PLANNING COMMISSION AGENDA

Re: Public Hearing: The Break Site Plan & Cross Access Deviation Request (Administrative Item)

Re: The Break – Site Plan & Cross Access Deviation Requests

Application No.: 2024-0356-SP & 2025-0271-VAR
Applicant: Gary Knapp, representing LM Restaurant Group, LC
Project Location: 12240 S. 700 E. & 12258 S. 700 E.
Current Zoning: CC (Community Commercial Zone)
Acreage: 1.02 Acres (Approximately 44,431 ft²)
Request: Request for approval of a Site Plan and a Cross Access Deviation in the CC zone.

SITE PLAN

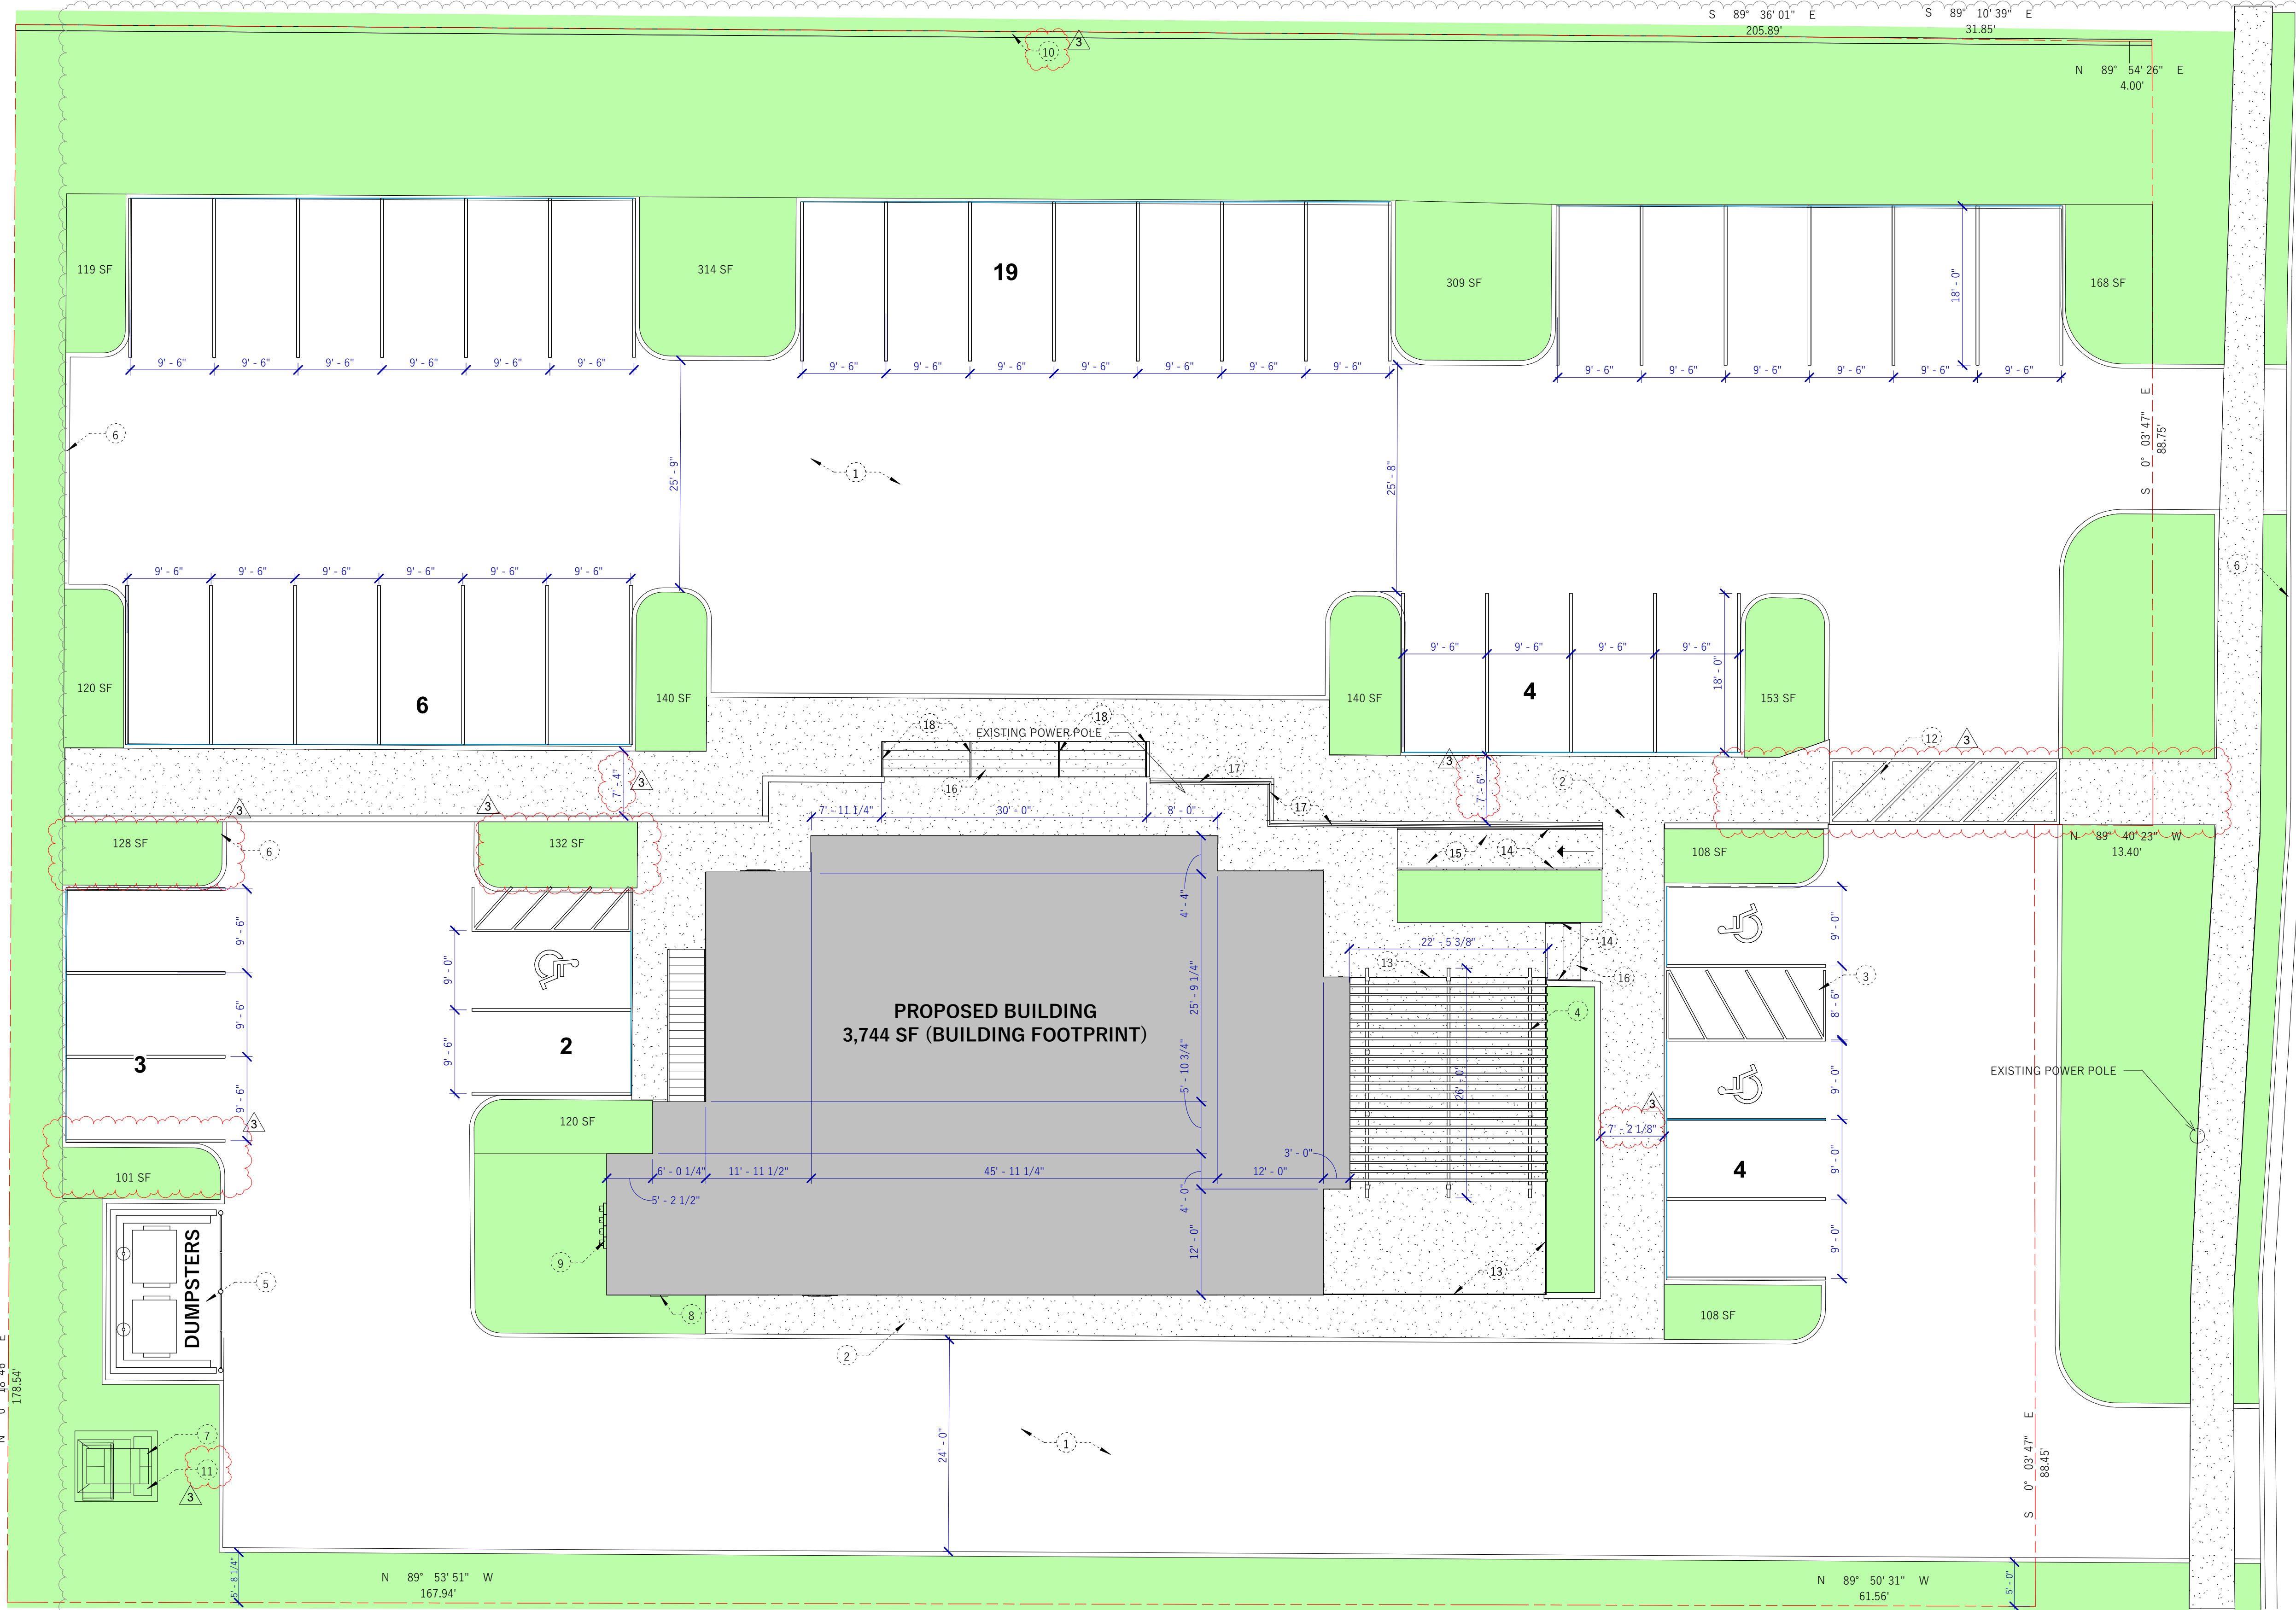
An eight (8) foot fence is detailed on the site plan along the north property line, however the construction details provided for the fence only show a 6' tall fence. As a condition of approval, the applicant will need to provide planning staff with a corrected construction detail showing an 8' tall fence prior to issuance of a building permit. Additional details can be found in table 7 and Exhibit J of this report.

5. That an eight-foot (8') masonry fence be constructed along the north property line, and that updated construction details be provided to planning staff for review and approval prior to the issuance of a building permit.
6. That the property be consolidated through recording of the previously approved amended subdivision plat prior to the issuance of the required land disturbance permit or building permit.

SITE PHOTOMETRIC
PLAN

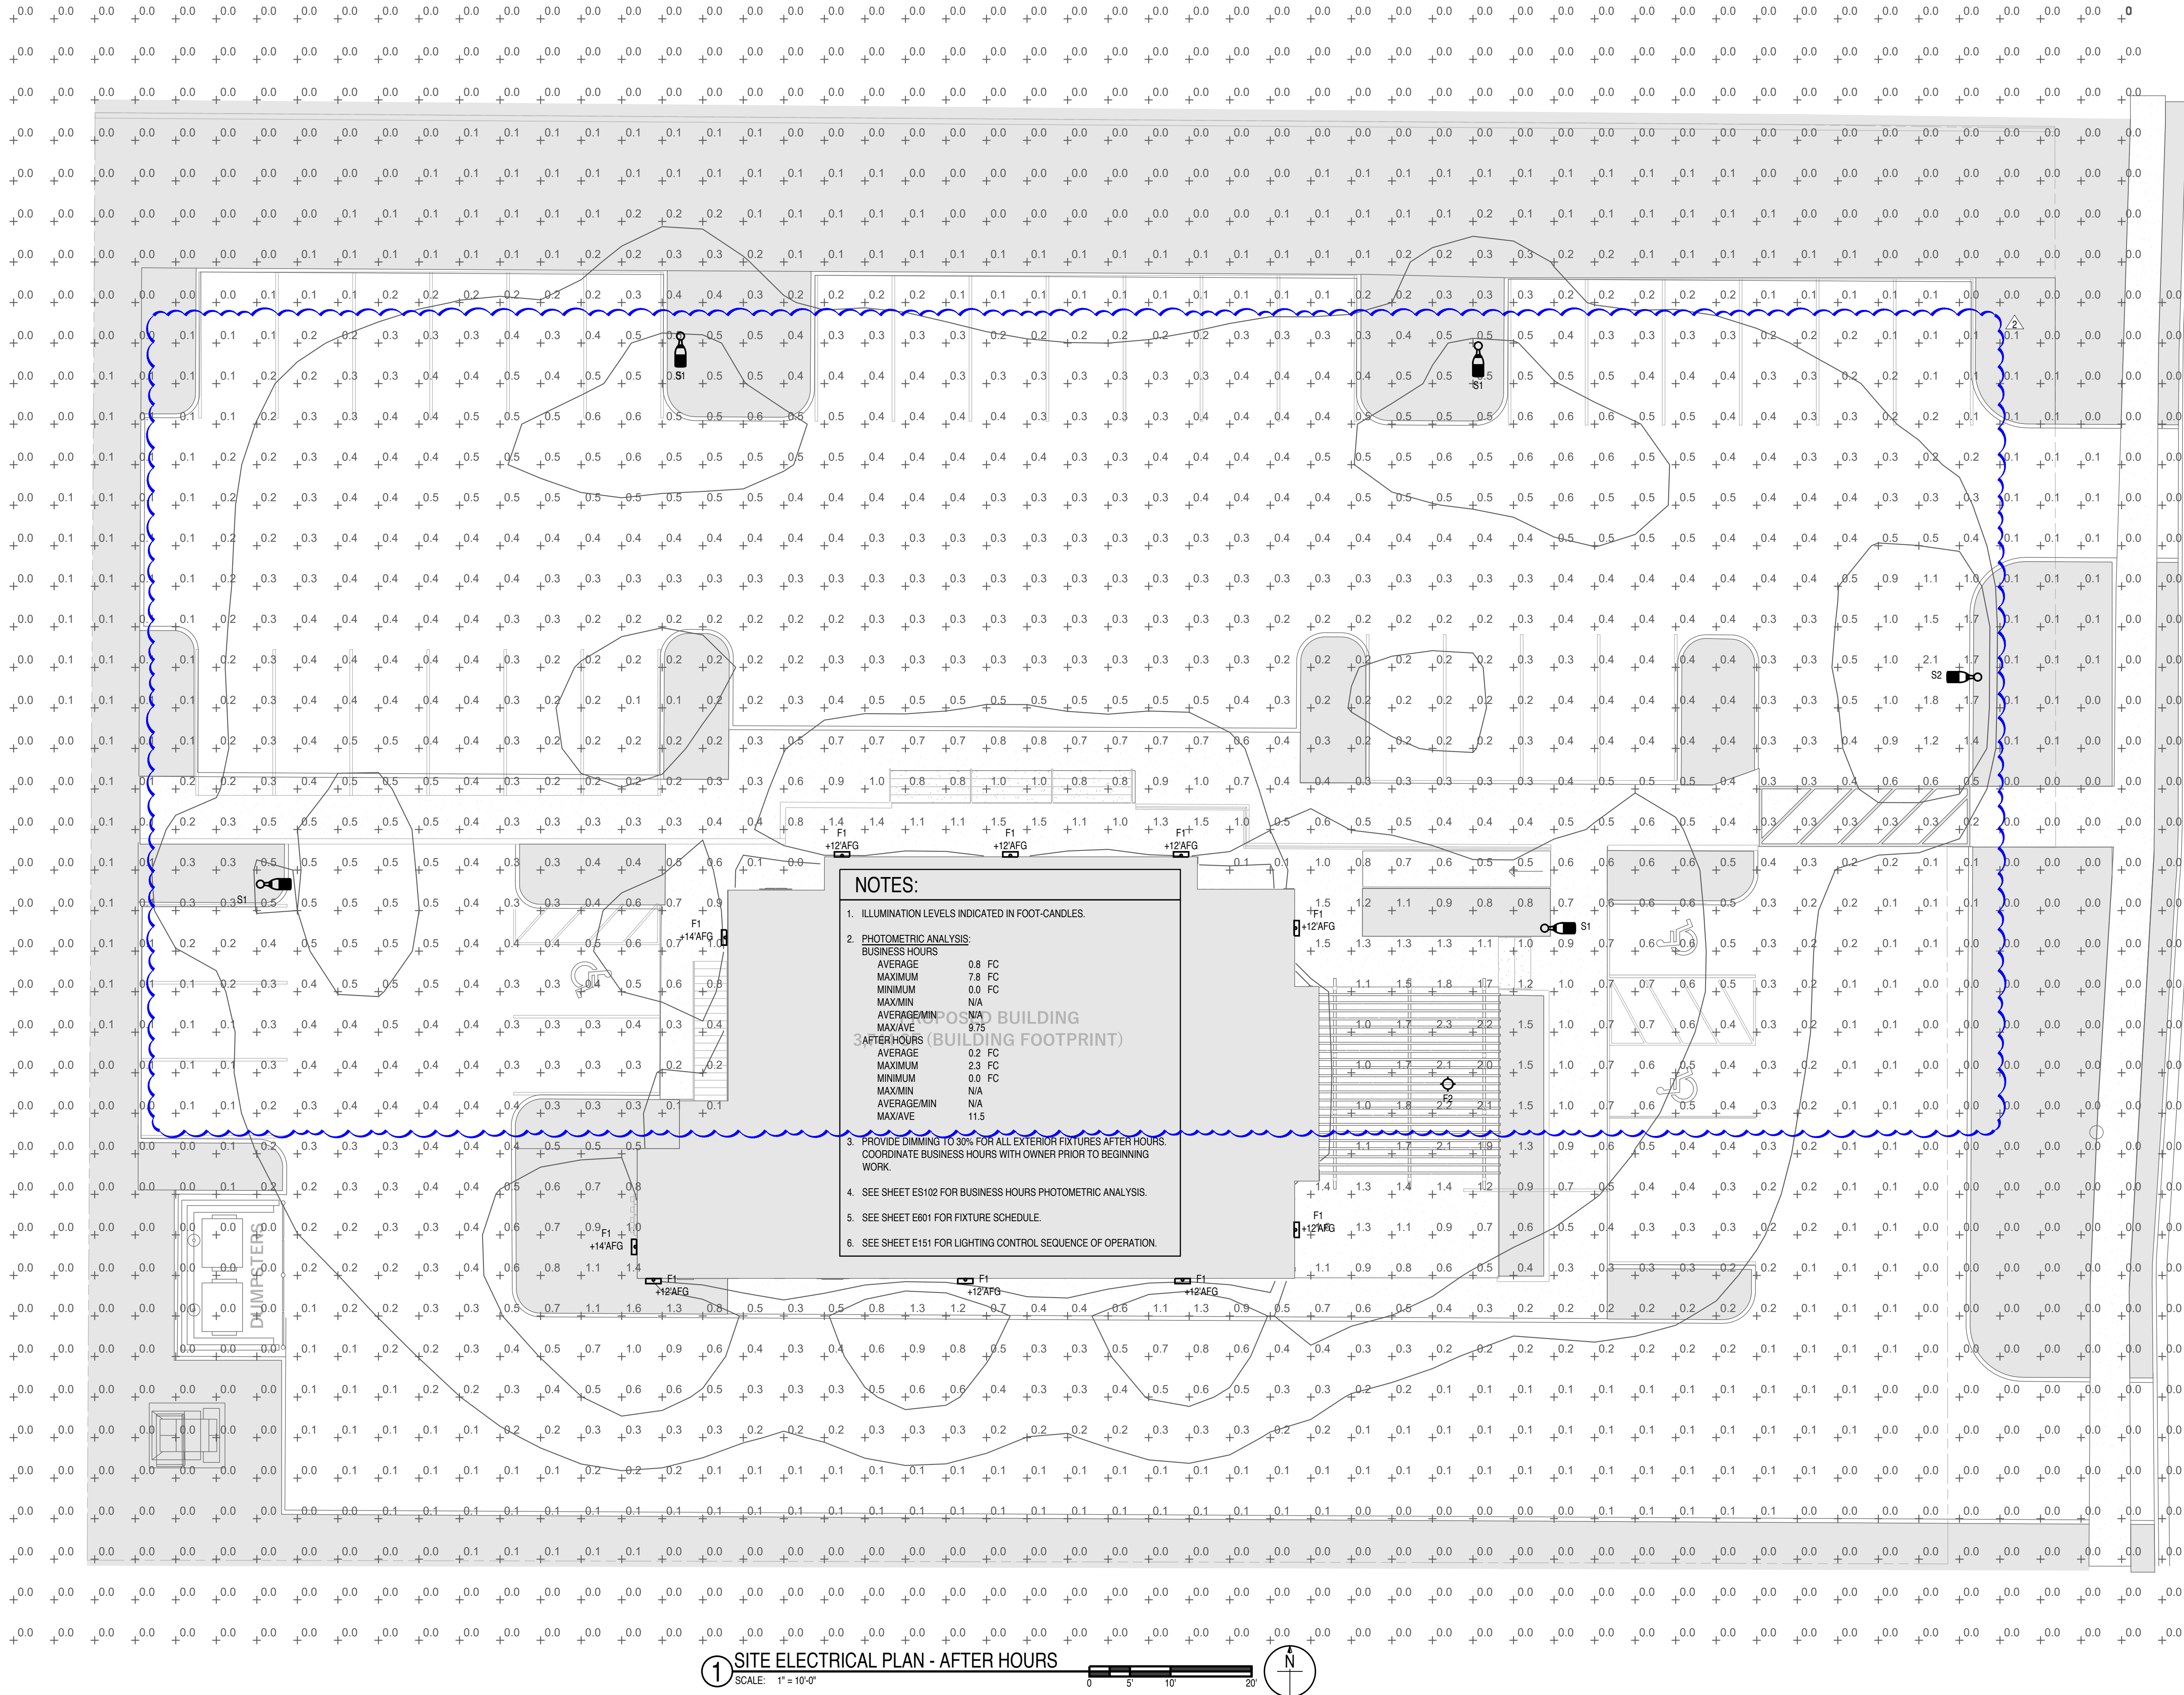
Staff notes that the plans (Exhibit I) comply with *most* of the lighting requirements of City Ordinance, however, the plans do not comply with the maximum illumination ratio. Staff recommends as a condition of approval that revised lighting plans that show a maximum illumination ratio of 2.5:1 be submitted to planning staff for review and approval prior to the issuance of a building permit. More details regarding the proposal and lighting design requirements can be found in table 6 of this report.

1. That all requirements of the Draper City Engineering, Public Works, Building, Planning, and Fire Divisions are satisfied throughout the development of the site and the construction of all buildings on the site, including permitting.
2. That the site shall be constructed and landscaped in compliance with the approved site plan and landscaping plan.
3. That the color of the light poles shall be black.
4. That revised lighting plans and photometric analysis in compliance with ordinance including the maximum illumination ratio of 2.5:1 be submitted to

planning staff for review and approval prior to the issuance of a building permit.
